A d d e n d u m

Iowa Department of Transportation
Office of Contracts Date

B.O.	Proposal ID	Proposal Work Type	County	Project Number	Addendum
452	31-2100-683	MISCELLANEOUS	DUBUQUE	TAP-U-2100(683)--8I-31	17NOV452.A01

Make the following change to the PLANS:

SHEET NUMBER **L-4**

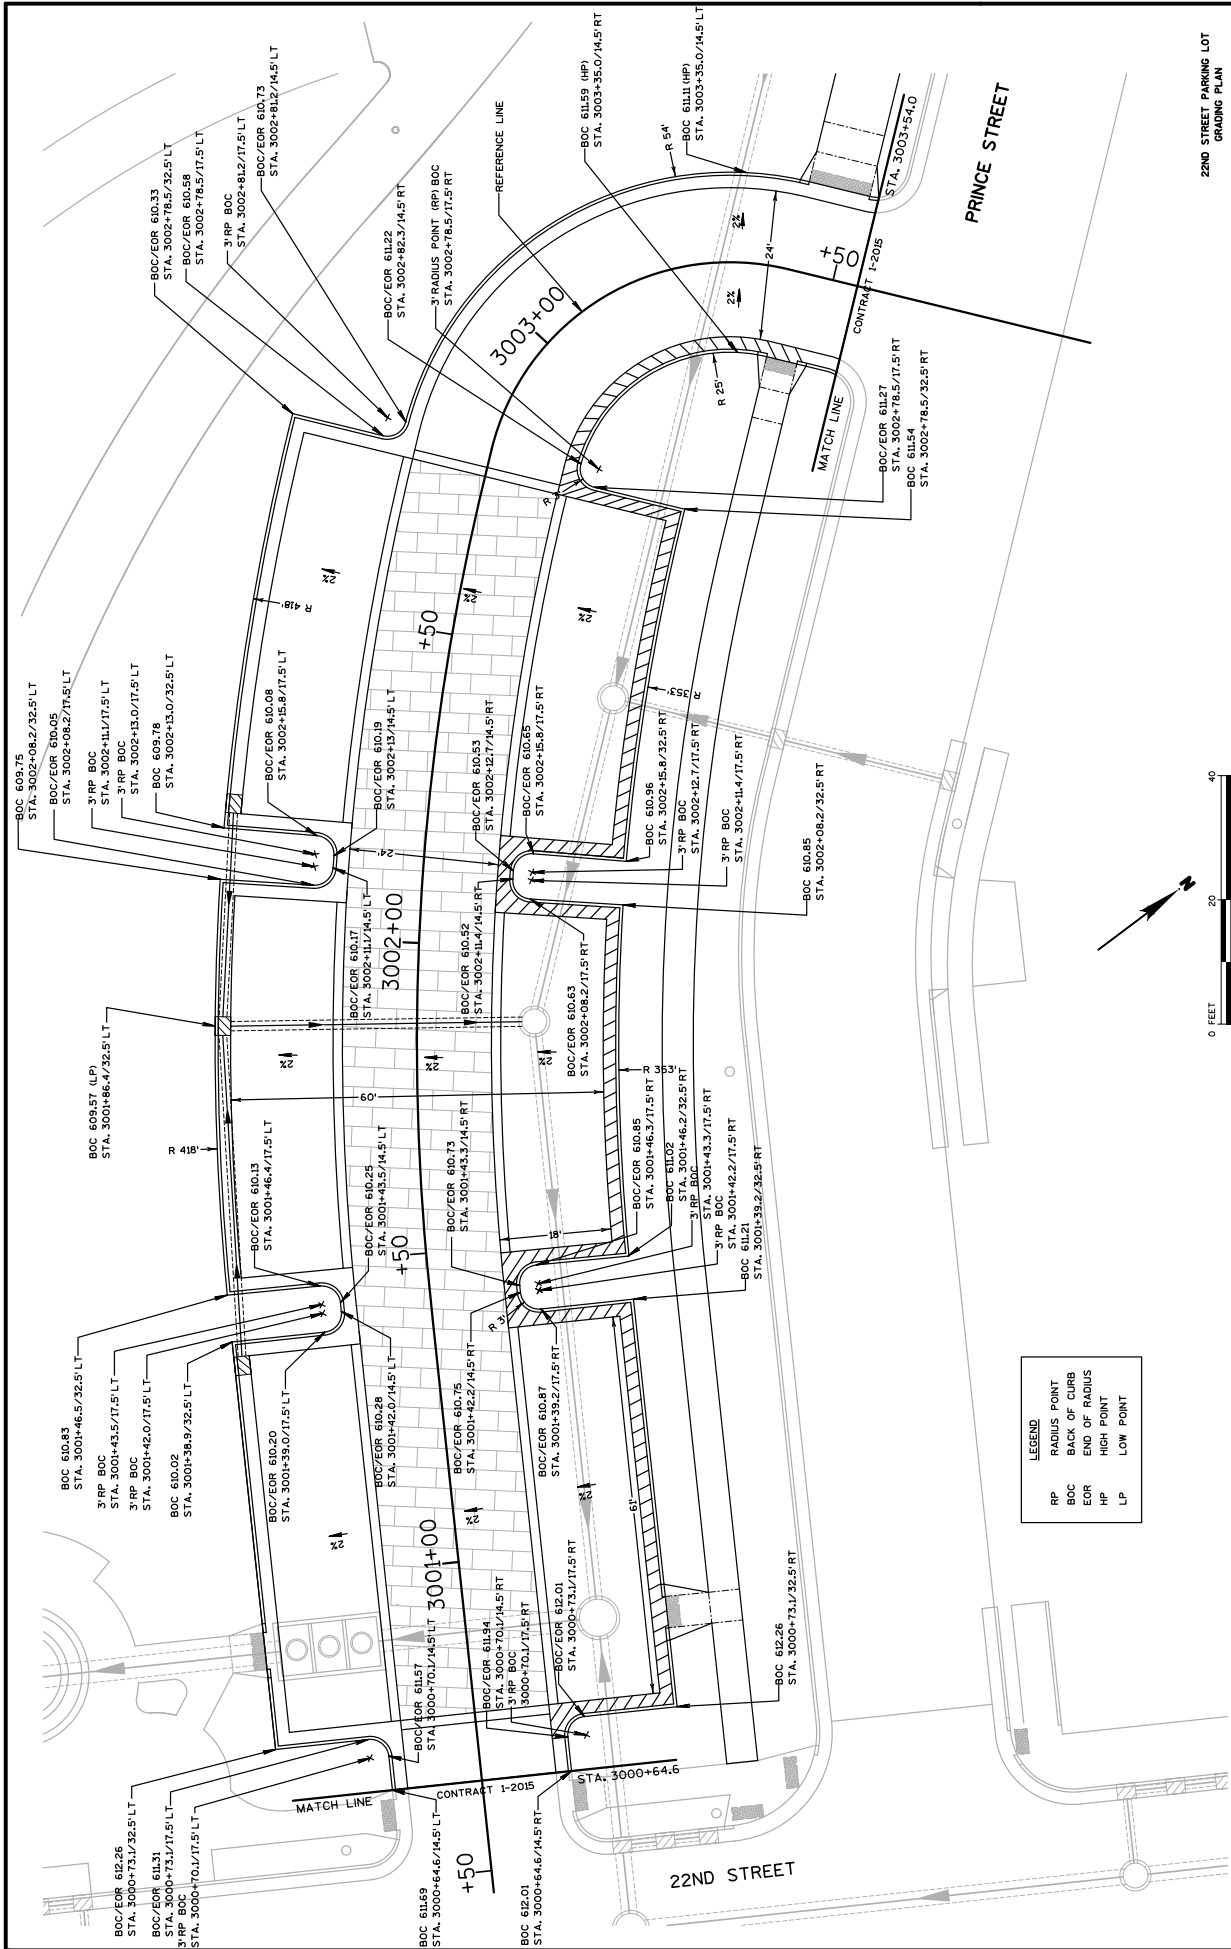
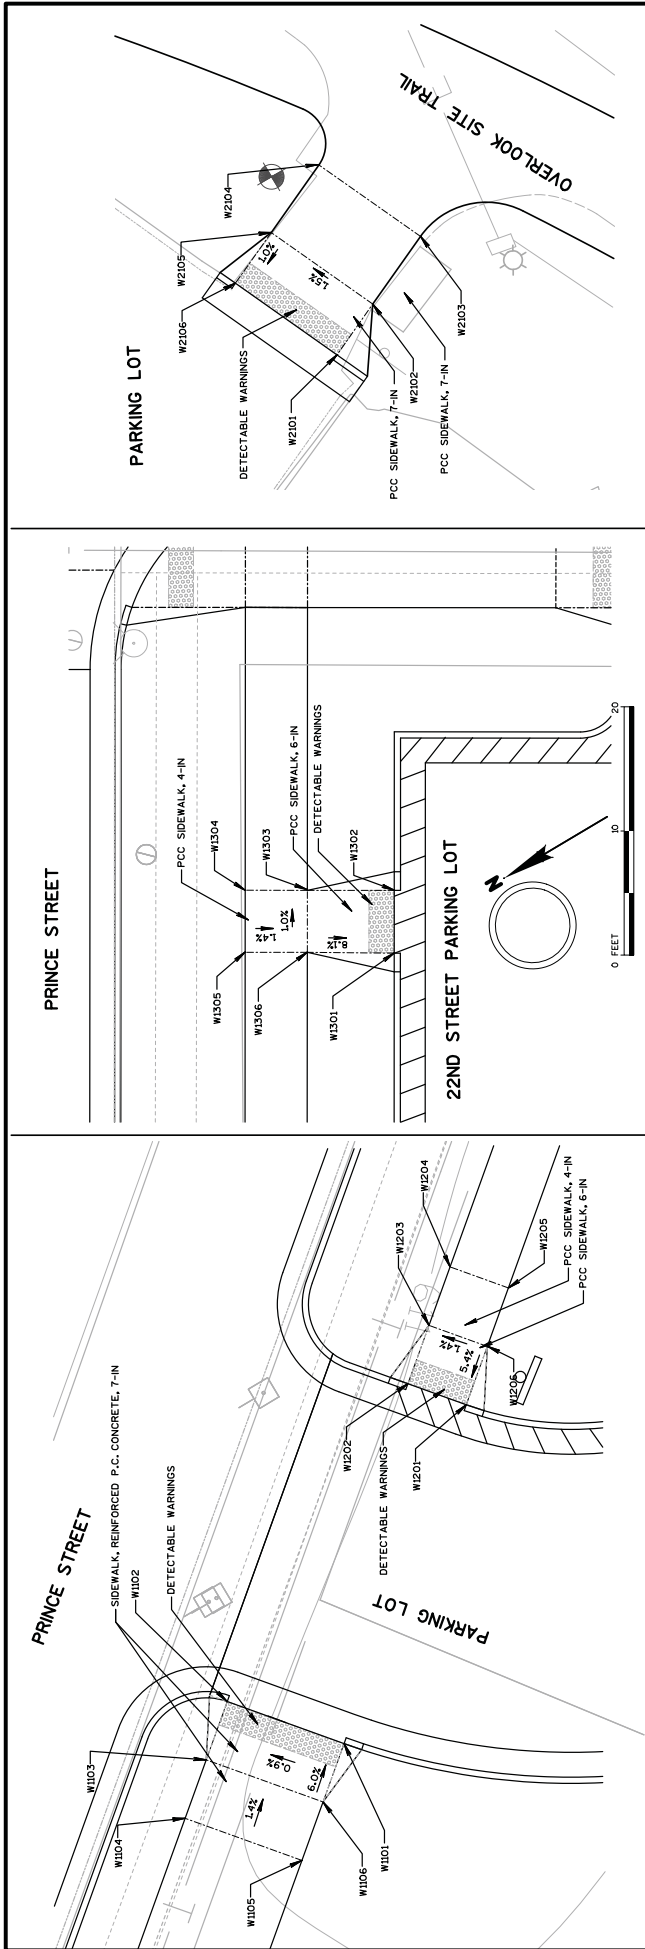
- Sheet A.2 - Added Note 5 to the General Notes Section
- Sheet D.1 - Revised rim elevation for Structure TP-3, removed 61' dimension from parking lot.
- Sheet L.4 - Revised multiple elevations
- Sheet S.1 - Revised multiple stations in table
